# Service Bulletin

S.B. No: 163

**Title:** INSPECTION OF FUEL VALVE TORQUE SHAFT UNIVERSALS

**This Issue 2** has been raised to incorporate the inspection at every 150 flying hours, (100 flying hours), previously one off inspection at 150 flying hours, (100 flying hours), this follows reports of further incidents of loose pivots. Additionally Mod M915 and M945 have been added to T67M200 and T67M260; plus aircraft 2267 to 2284 added as not applicable. Service Bulletin generally updated note marks in left hand margin indicating areas of change.

**FIG. 1 FUEL SELECTOR VALVE SHAFT DETAIL**  
 [T67M200 (Post Mod M915), T67M260 (Pre Mod M945), T67M260-T3A (Pre Mod M830)]

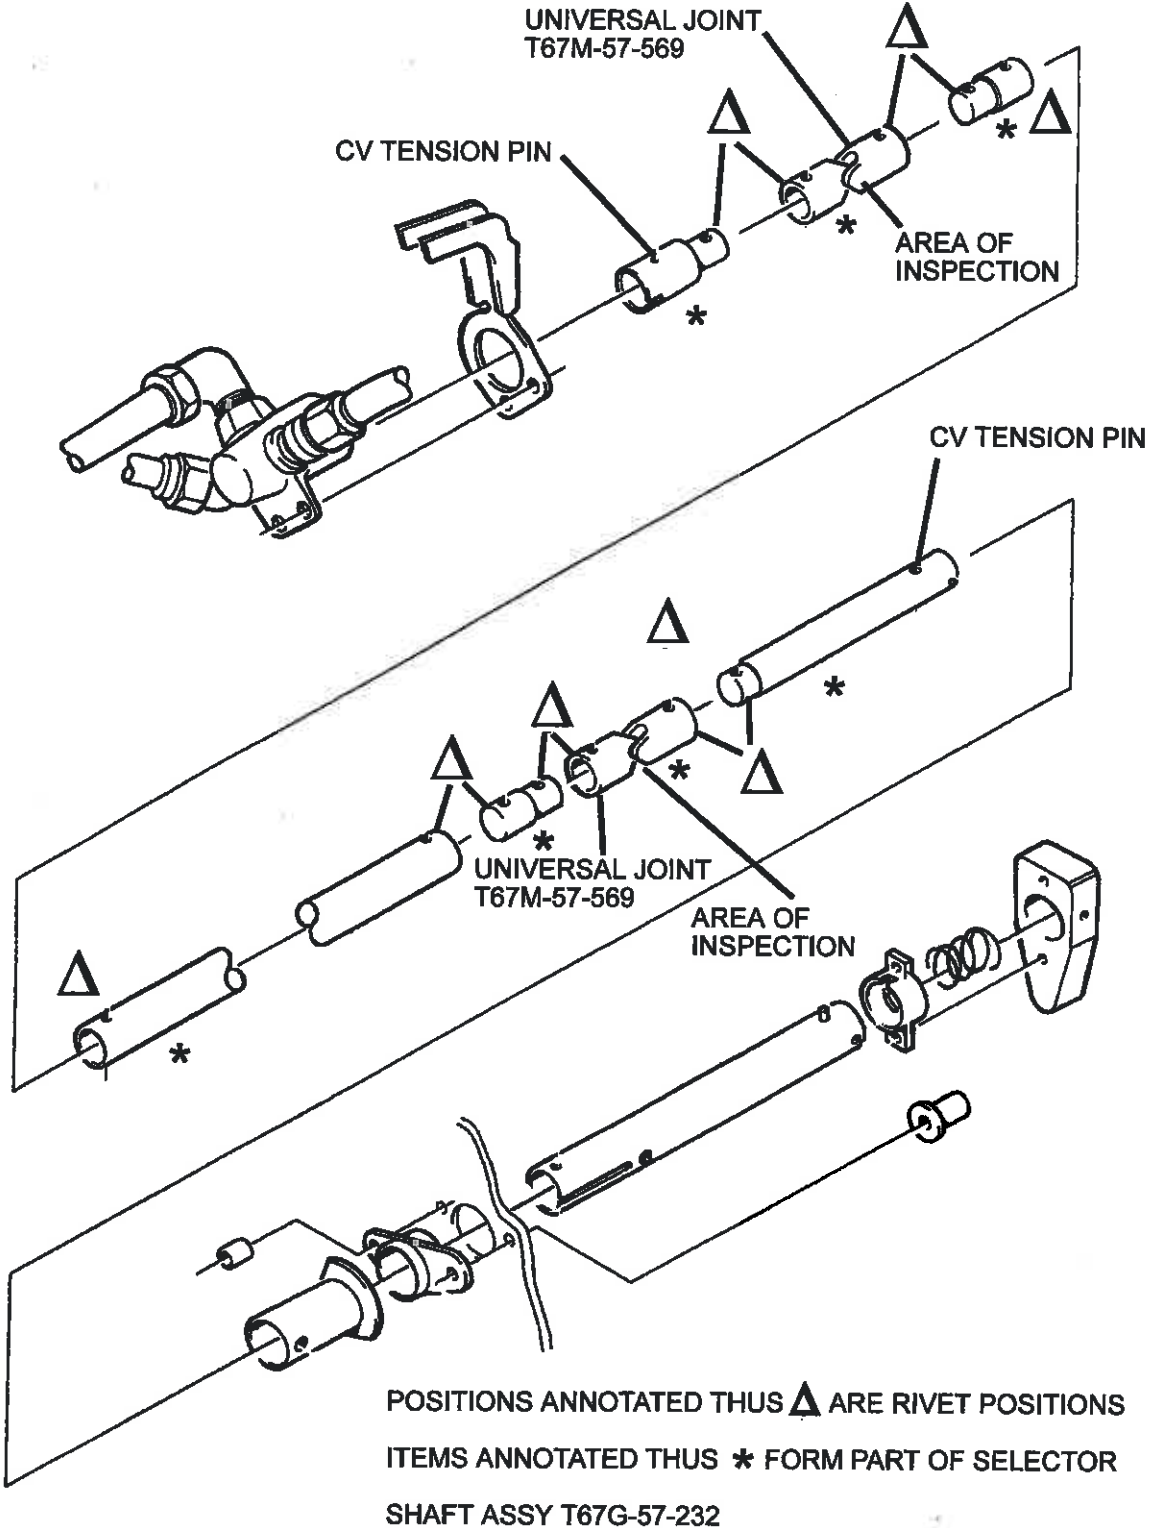
4. a. T67M200 (Post Mod M915), T67M260 (Pre Mod M945) and T67M260-T3A (Pre Mod M830), Figure 1:

If there is any evidence of wear or physical damage to the universal joint/s, then remove the torque shaft assembly T67G-57-232 and replace either the torque shaft assembly or the relevant universal joint (T67M-57-569) on the shaft. Reassemble torque shaft assembly back into the aircraft.

**FIG. 2 FUEL SELECTOR VALVE SHAFT DETAIL**  
[T67C POST MOD M156, T67M-MKII, T67M200 (Pre Mod M915)]

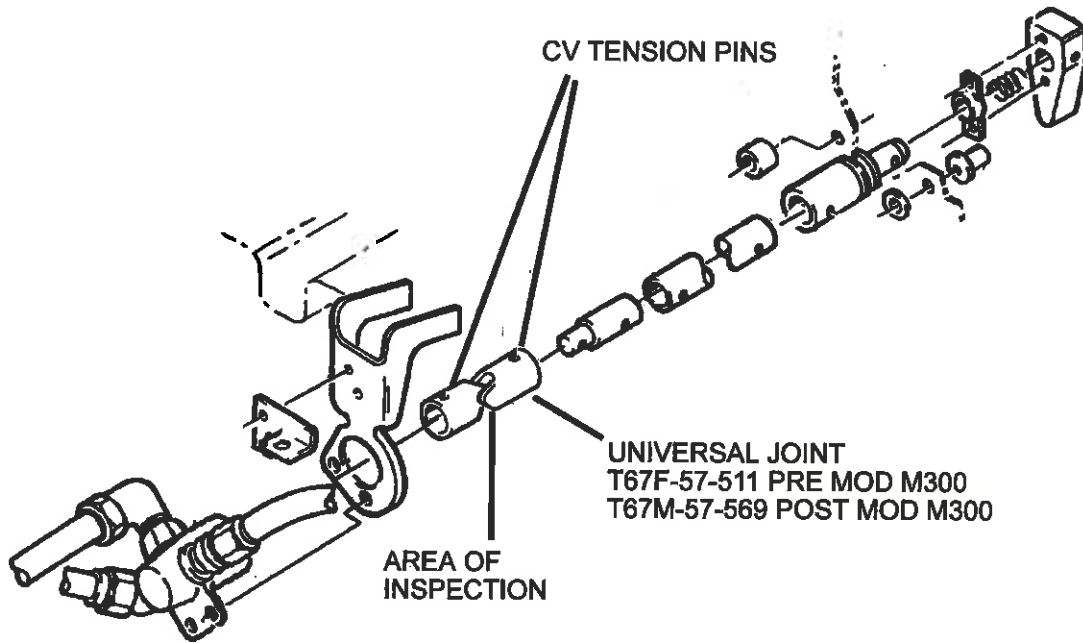
- b. T67C Post Mod M156, T67M-MkII and T67M200 (Pre Mod M915) Figure 2:

If there is any evidence of wear or physical damage to the universal joint then remove the universal joint, (T67F-57-511 Pre Mod M300, T67M-57-569 Post Mod M300) from fuel selector valve and shaft adapter assembly. Reassemble back into aircraft new relevant universal joint.

7. The assembly and reassembly cautions contained in paragraph 5 are to be added to the relevant aircrafts Maintenance Manual at next amendment.
8. T67C Post Mod M156, T67M-MkII and T67M200 only: IPC is incorrectly drawn ref universal joint. Figure 2 shows correct configuration. IPC will be amended in due course.
